CROSS RIVER RAIL

Environmental Impact Statement

Request for Project Change

February 2017

Figure 3-3 - Alignment Comparison - Reference Project (2011) shown as blue and Changed Project shown as green

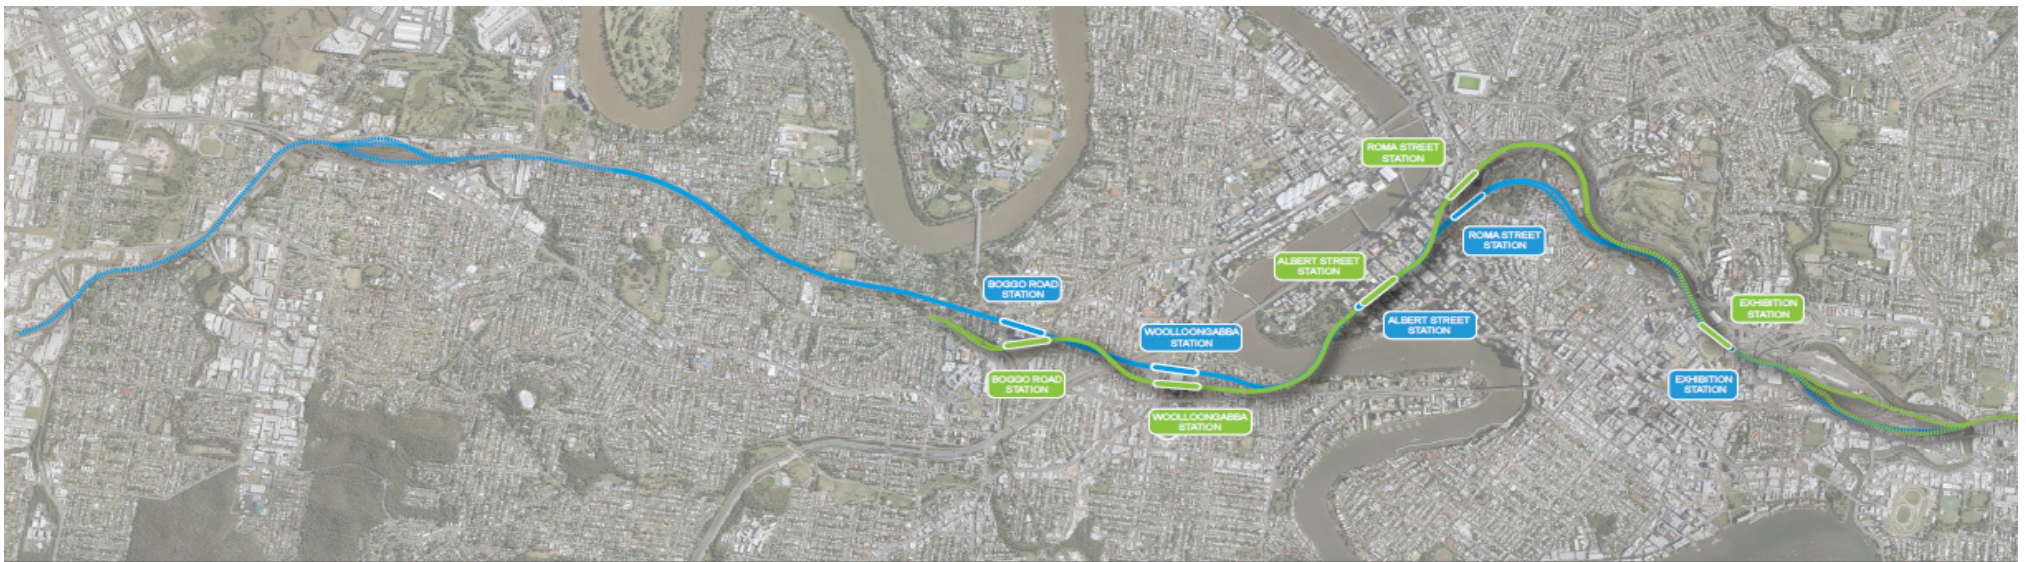
There are a number of changes to the Reference Project that are the subject of this Request for Project Change. These changes are referred to as the Changed Project and are illustrated in Figure 3-1. The Reference Project is illustrated in Figure 3-2, while a comparison of the two project alignments is shown in Figure 3-3.

There would be a change in the horizontal alignment of the route between Dutton Park and Woolloongabba to accommodate both the changed southern connection and maintain rail track grade requirements (maximum gradient of 3%). The route also changes between Woolloongabba and Albert Street to accommodate the track grade requirements and allow the tunnels to pass beneath the Brisbane River in the same location as the Reference Project in stable rock conditions.

North of the relocated Albert Street Station, the route changes to accommodate a new location for the Roma Street Station under the existing Brisbane Transit Centre (BTC) site. The route then moves further west before heading north beneath Countess Street and Hardgrave Park to connect with the surface rail network on the Exhibition Line. A single new track would be provided along the Exhibition Line from the northern portal into Mayne Yard. Two new tracks would pass through Mayne Yard to provide connections with the North Coast Line.

Figure 5-3 - Roma Street Station – concept layout for pedestrian footpath treatments and crossing facilities

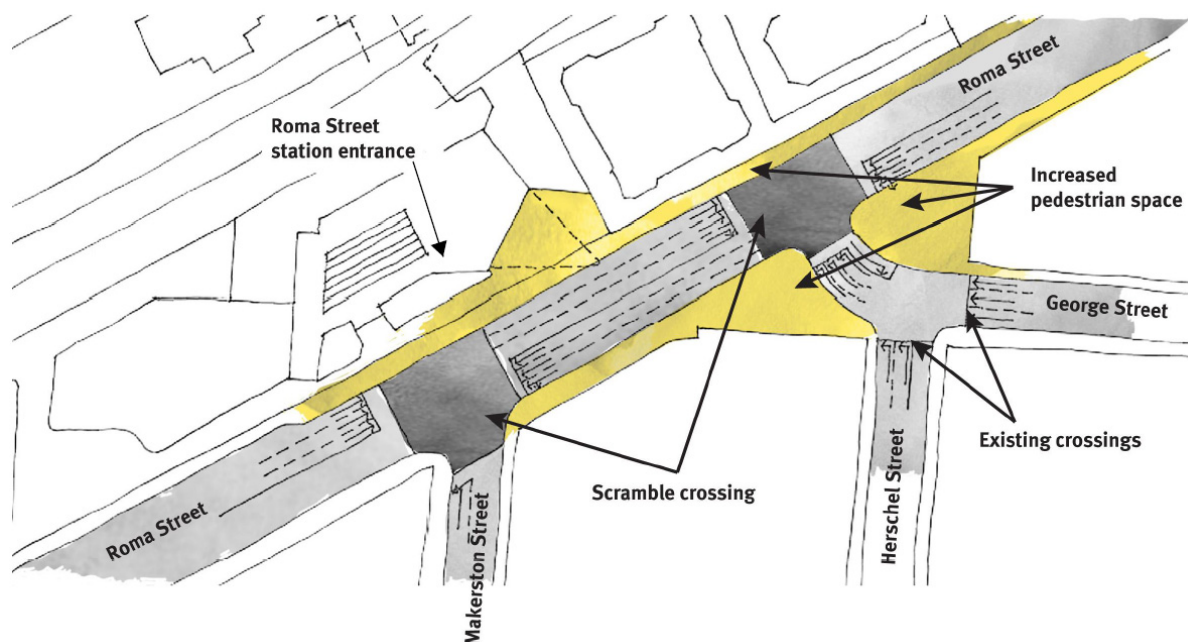
Figure 5-3 illustrates a possible conceptual layout for the Roma Street area to improve the pedestrian environment.

The conceptual layout includes the creation of a signalised T-intersection of George Street and Roma Street that would include a scramble pedestrian crossing. The T-intersection would be created through the re-alignment of George Street at Roma Street and the removal of the short section of Herschel Street between George Street and Roma Street. The layout has the following key features:

Figure 5-5 - Compliance trackform requirements, Reference Project and Changed Project

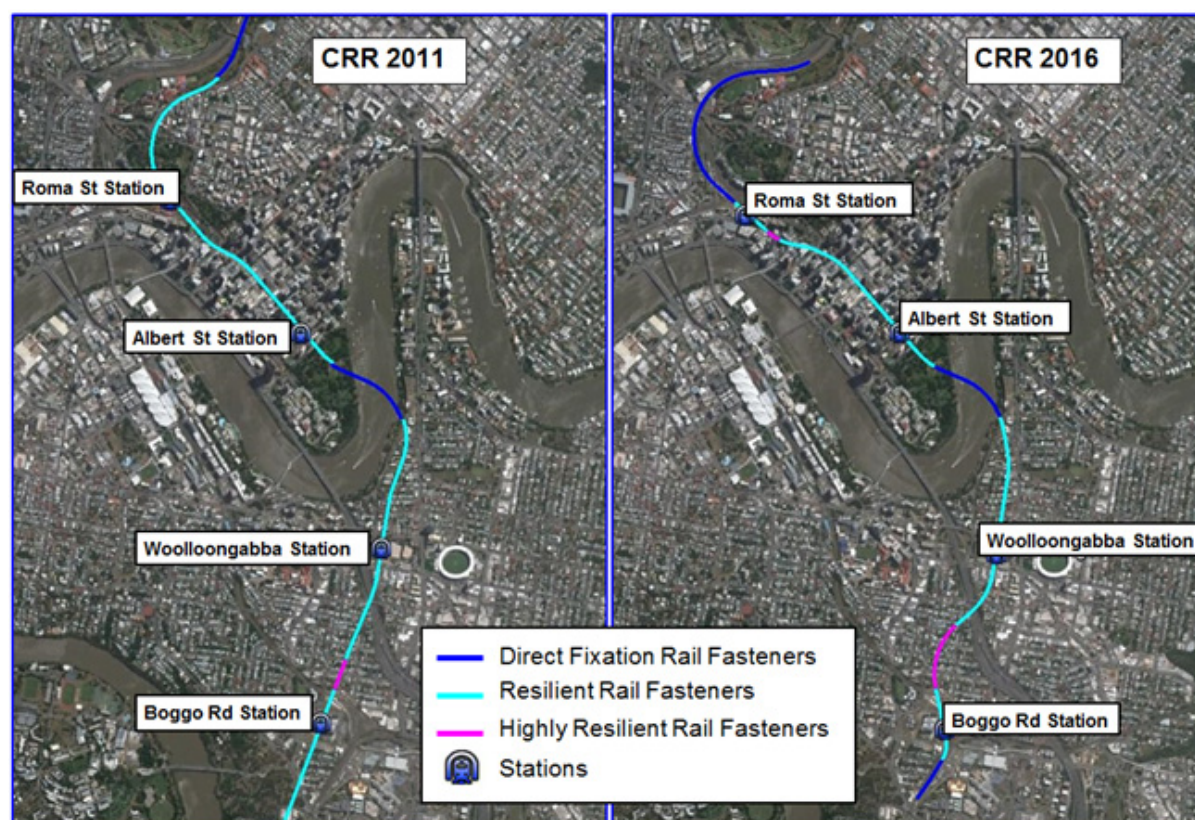
To achieve the criteria for ground-borne noise the extent of the Highly Resilient Rail Fasteners for underground track north of Boggo Road Station is slightly extended in the Changed Project compared with the Reference Project. The comparative requirements are illustrated in Figure 5-5.

Figure 5-8 – Changed location of Roma Street Station

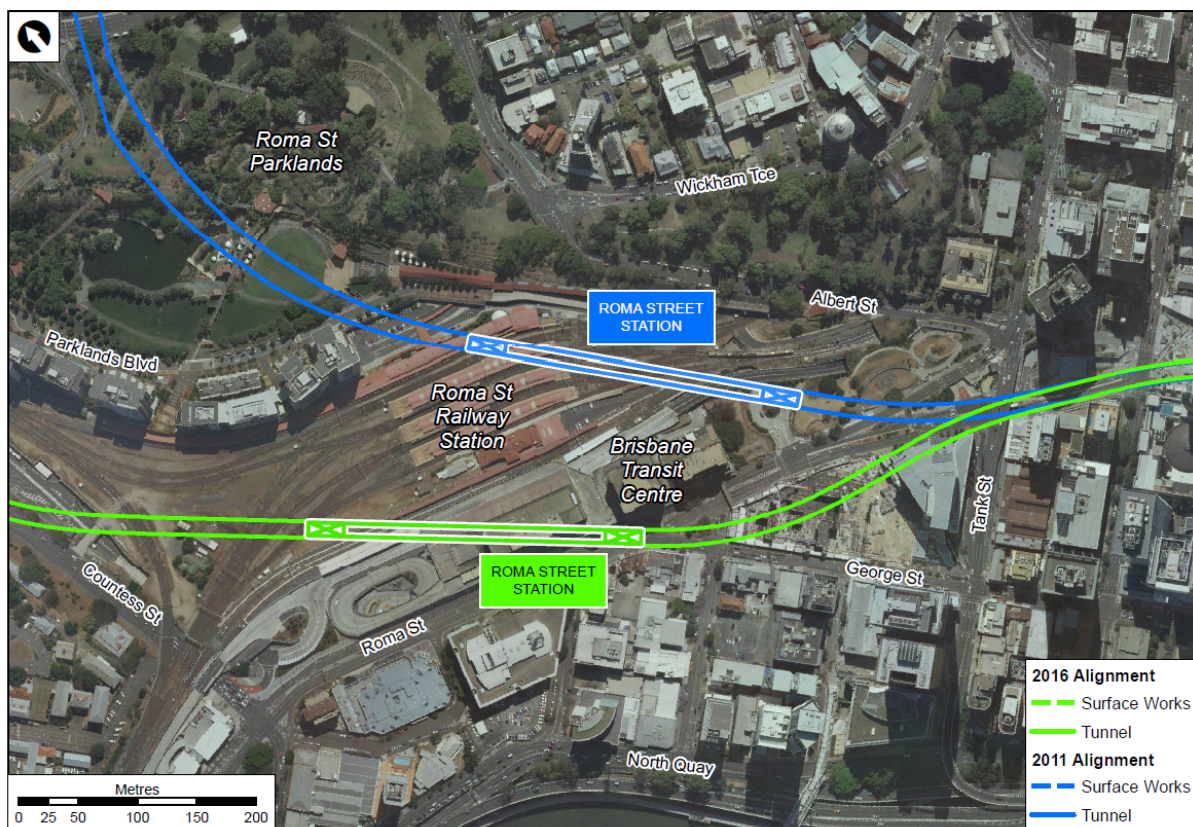
The Changed Project involves a realignment of the tunnels between Turbot Street and Roma Street, and a consequential change to the location of the underground Roma Street Station. The change in location of Roma Street Station is illustrated in Figure 5-8.

Figure 5-10 - Alignment changes at Mayne Yard

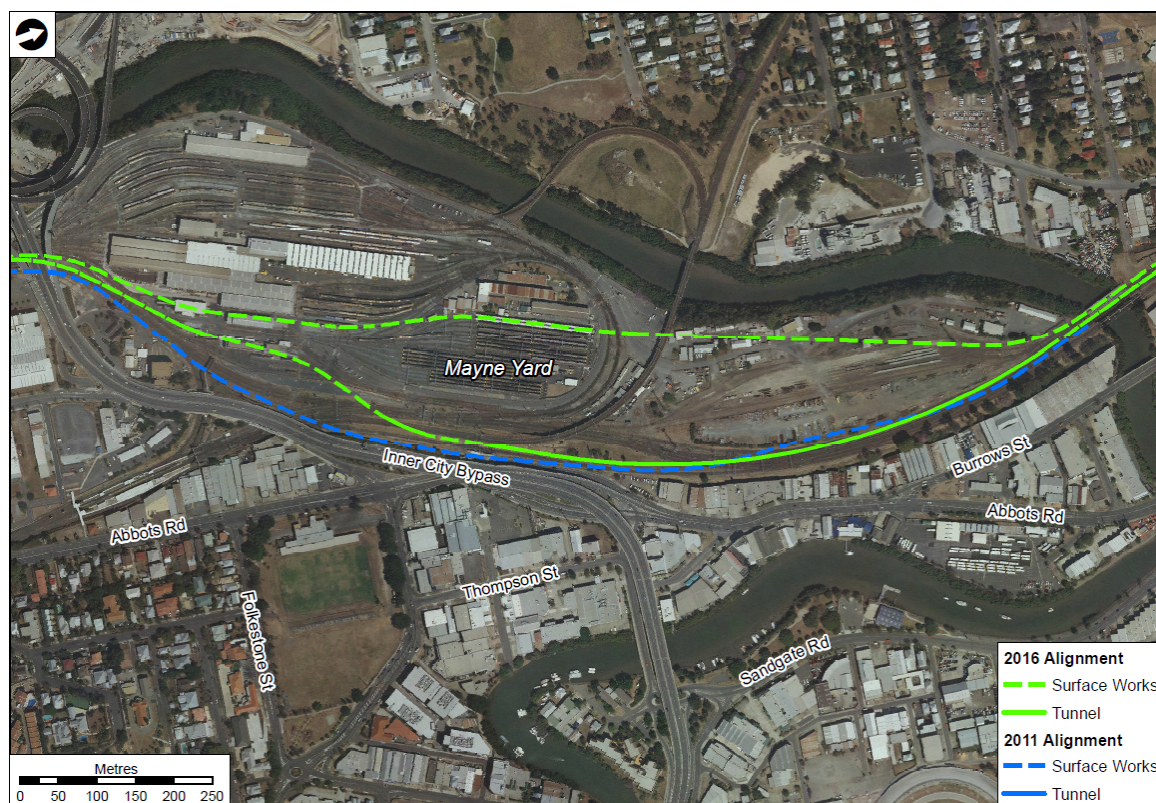
The Changed Project would have a similar, although slightly larger, footprint in Mayne Yard compared with the Reference Project. The Changed Project would allow greater flexibility in the use and operation of Mayne Yard and would avoid the potential operational conflicts that might arise with the Reference Project. This benefit is achieved by separating the CRR tracks from the northern line tracks by way of an underpass (trough structure) just north of the Ferny Grove viaduct. The change in alignment through Mayne Yard is illustrated in Figure 5-10.

Figure 6-3 - Changed Project Boggo Road Station worksite

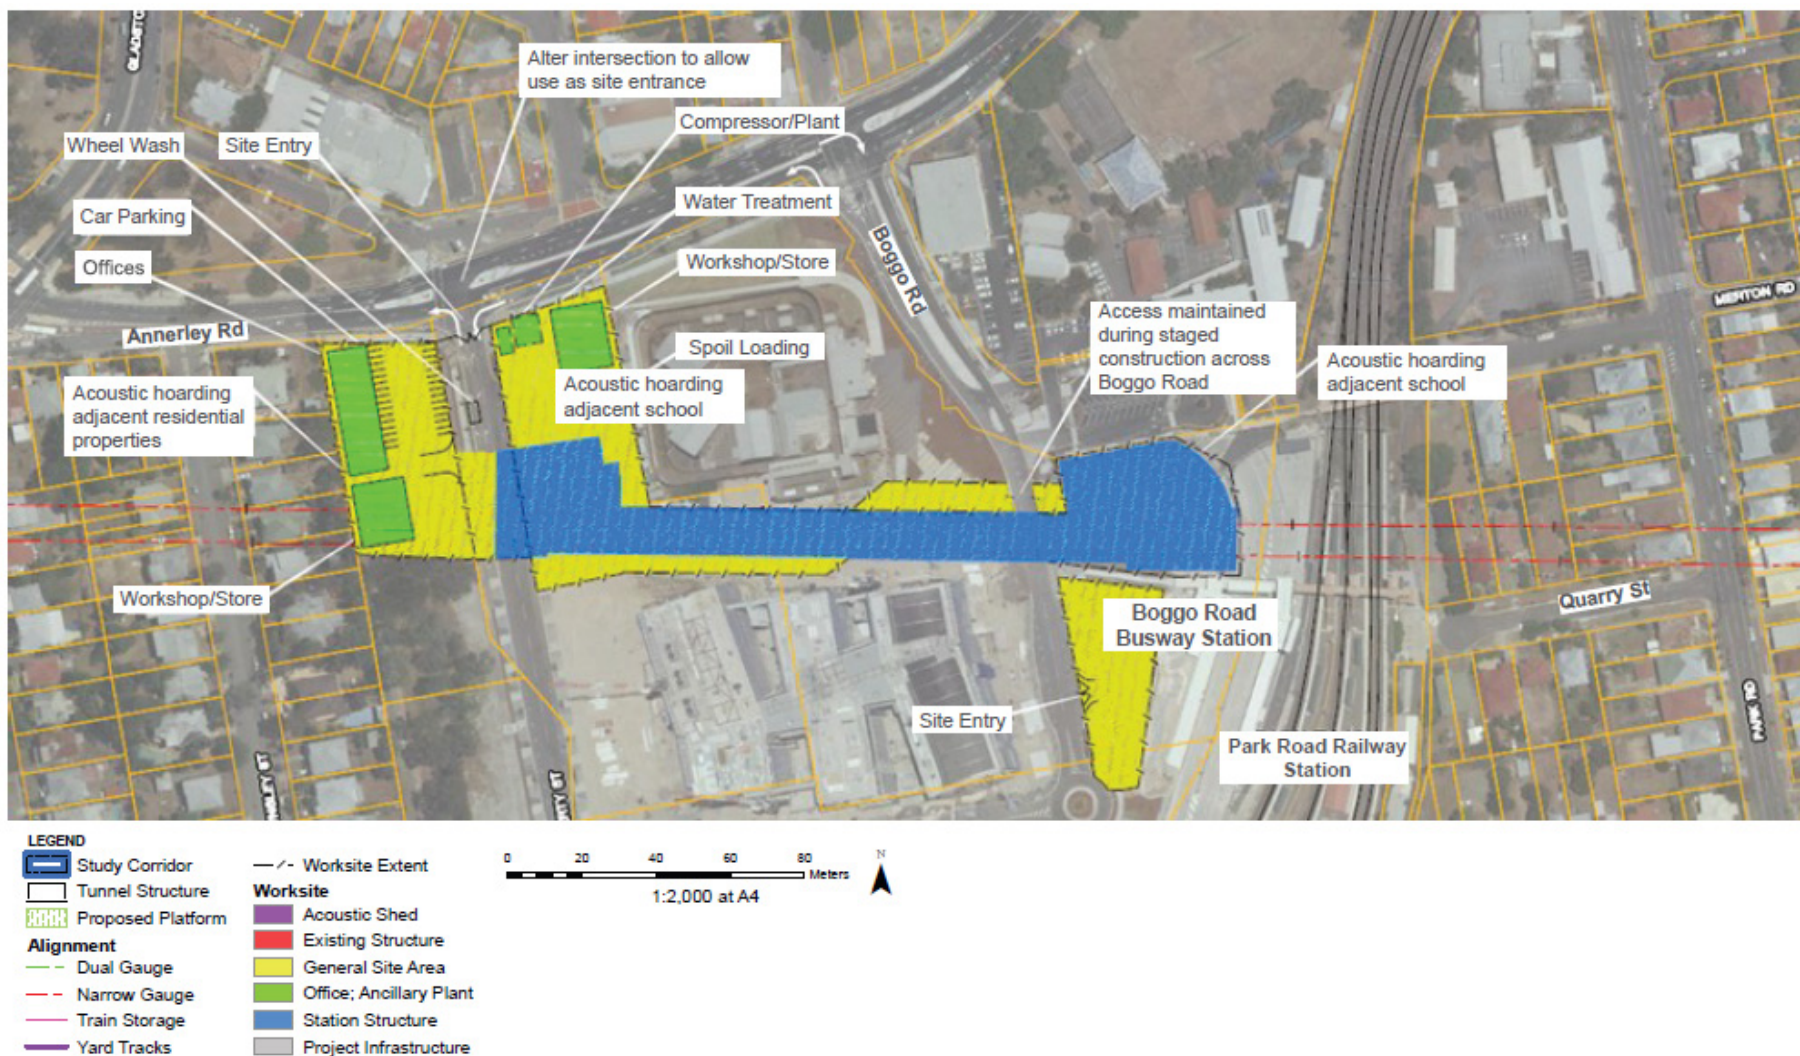
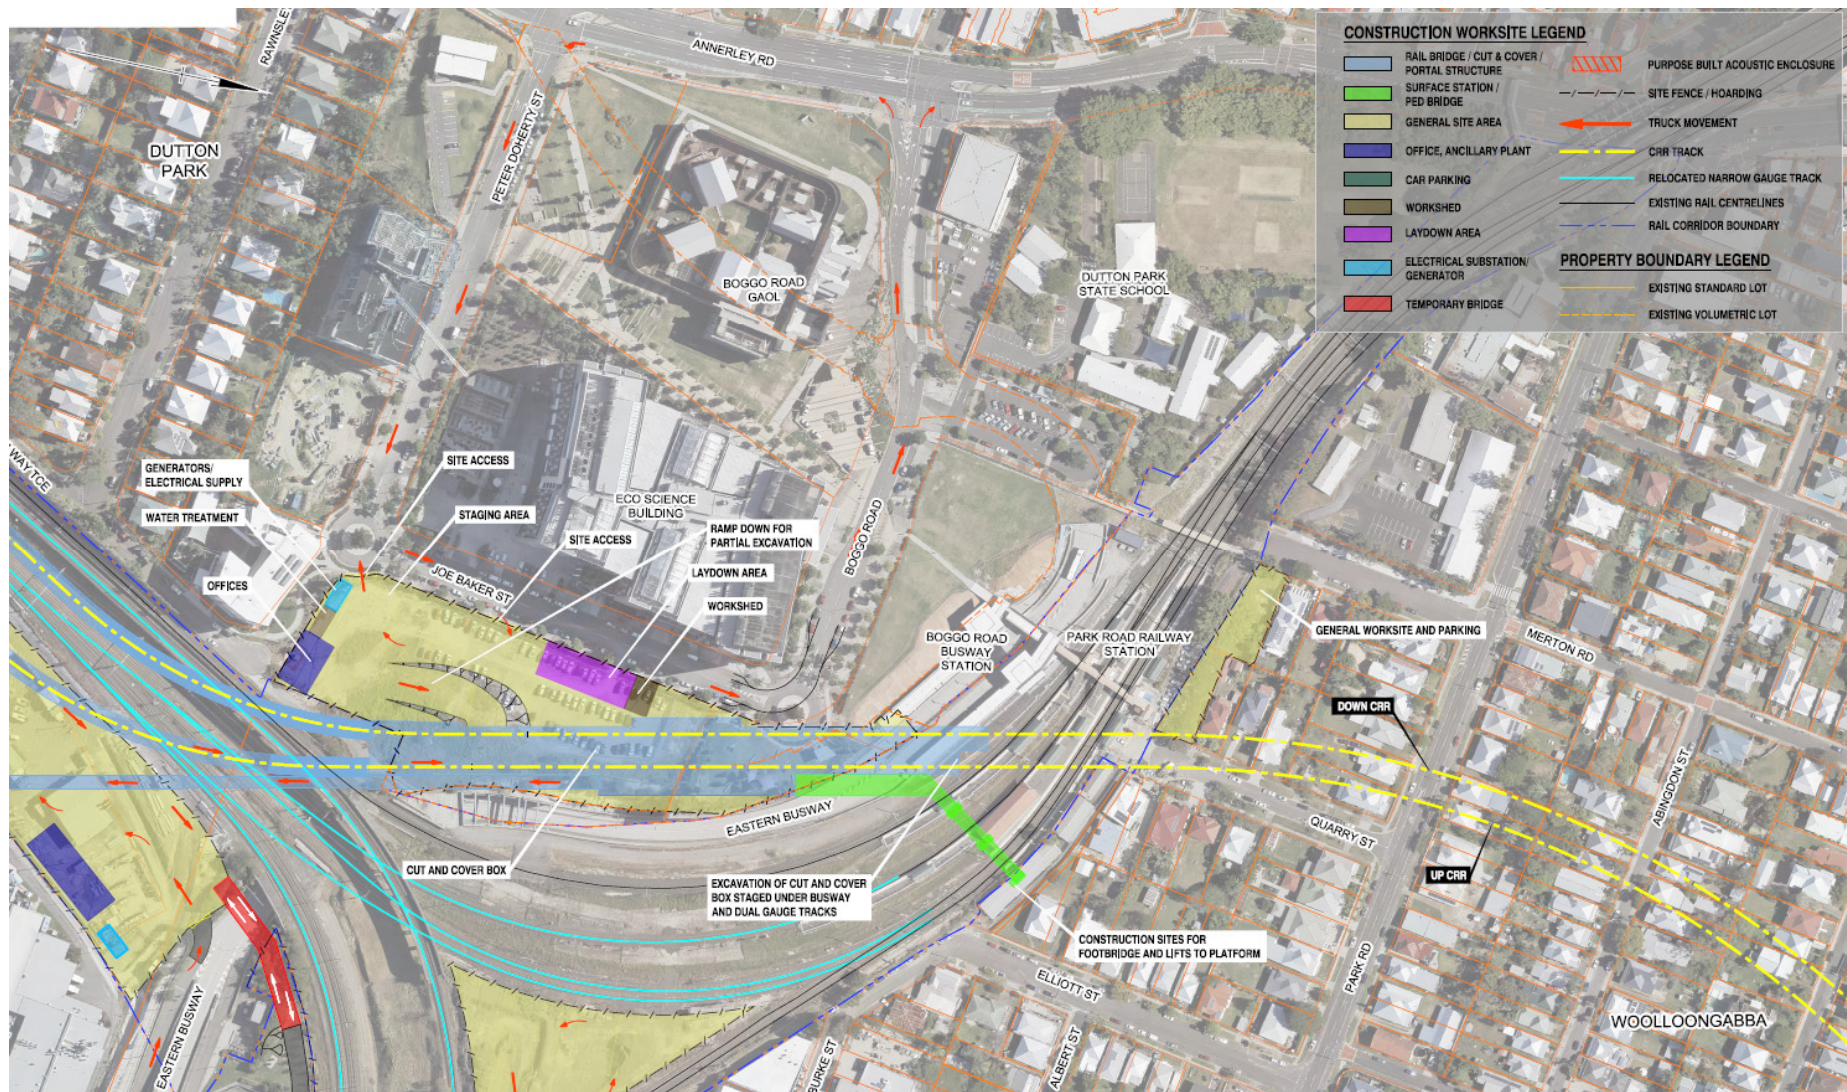
The Southern Portal would be constructed through surface excavation works leading to cut-and-cover works for the connections to the Boggo Road Station cavern. The station would be constructed by cut-and-cover methods. The Changed Project worksite for the Southern Portal is shown in Figure 6-1. The Reference Project and Changed Project worksites for Boggo Road Station are shown in Figure 6-2 and Figure 6-3, respectively.
